## Request for Class II Permissive Change

FCC ID: VG8XM031MYY

Data: December 3, 2011

1. Updated Mainboard as below:  
Original Mainboard

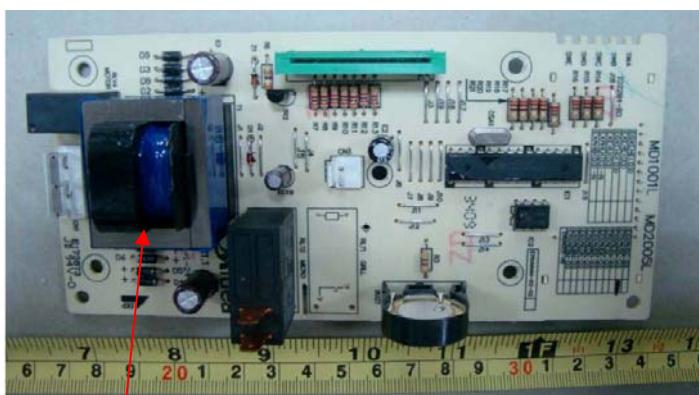
Changed linear power supply to switching power supply.

Note: Between them have the same specification of rated output power, changed to the switching power supply, rated output power have not obvious changes.
